RECOMMENDATION OF WATERMASTER

Application No: 75772

Applicant's Name: Six S Ranch LLC

Transfer No. 75772
Applicant: Six S Ranch LLC
Subject: Adding an Additional Point of Diversion on White Pine Creek
Ref: Attachment #7A (modified)

ATTACHMENT #7a

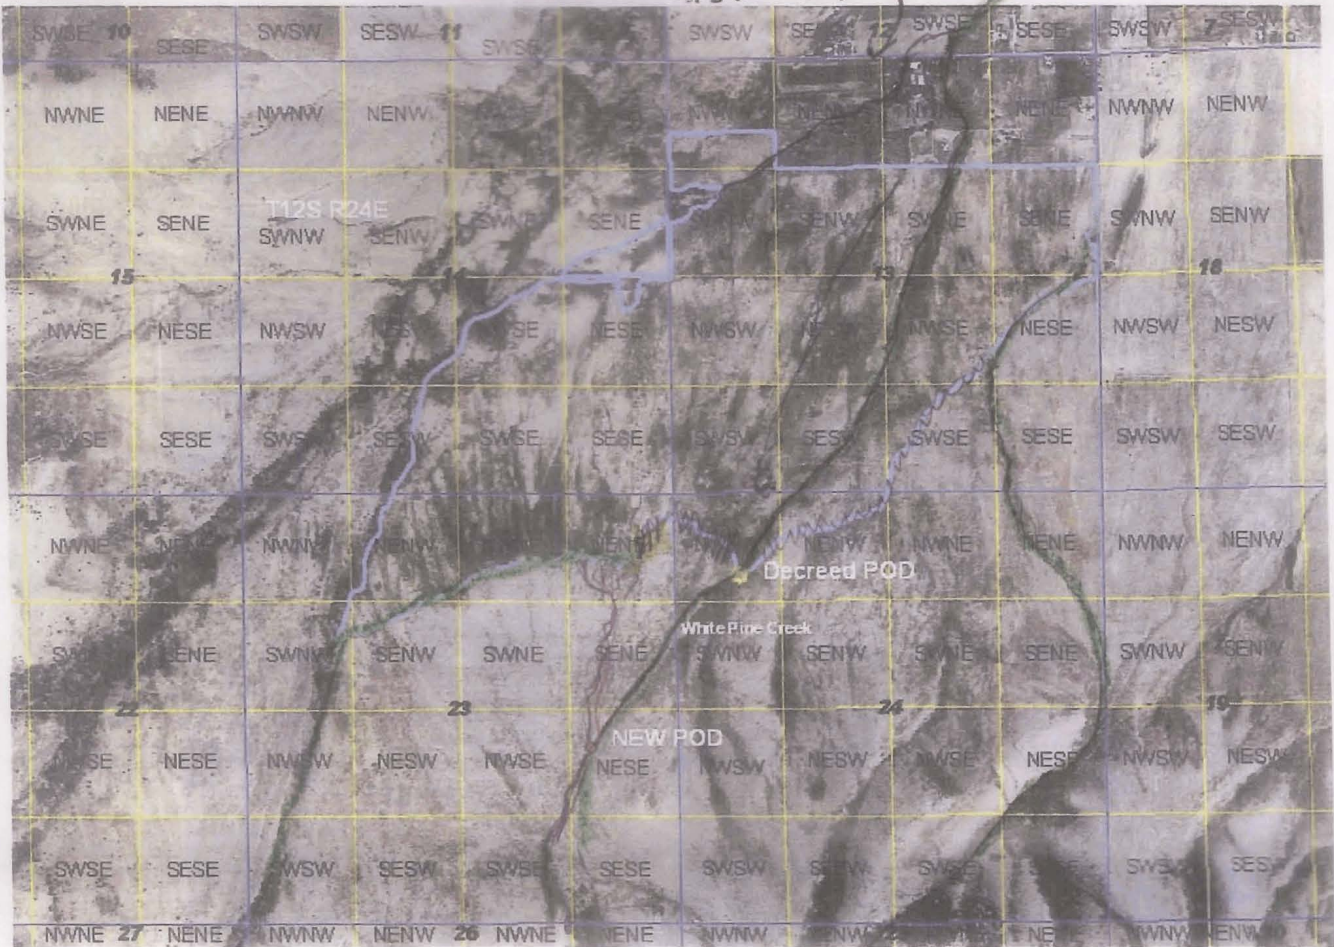
As the water master of MCWD45F, I have no problem with the additional diversion point on White Pine Creek at Section 23 NWNESE. But what is shown on the map that was submitted is incorrect on what you show in attachment #7A. I have included a modified version to be used to cross-reference what I am trying to get corrected.

- 1) From the New POD channel which runs directly into the original Decreed POD in Section 24 SENWNW but you show White Pine Channel running all the way over to 1050 East (road) in section 13. This is incorrect. The White Pine Channel runs directly down into section 13 (NWNE) grid across 1000 South (under road) into section 12 (SWSE) grid into Land Creek (as its return) Channel.

- 2) The Brim Creek Channel begins back up in Section 25 (SWSE) or above that location. It runs almost into 1050 East (road) but swings to the NW and drops on down into the area of section 13 (SENE) under 1050 East road (which was the original channel). It will be noted that the way the contours of the ground when irrigated, both White Pine and Brim Creek will intermingle but neither creek joins together as pictured in attachment 7A.

- 3) It will also be noted that Land Creek Diversion "LA" lateral in Section 23 heads due East and connects with White Pine Decreed POD, that's incorrect. The lateral basically will end in Section 23 (NENE) grid and falls with contour of ground going NW and dropping into other laterals and head east towards Park Lane Rd. Only when the NEW POD is used will the water intermingle with the Land Creek water on the "LA" lateral.

Water Masters modified layout of Attachment 7A
Cory -
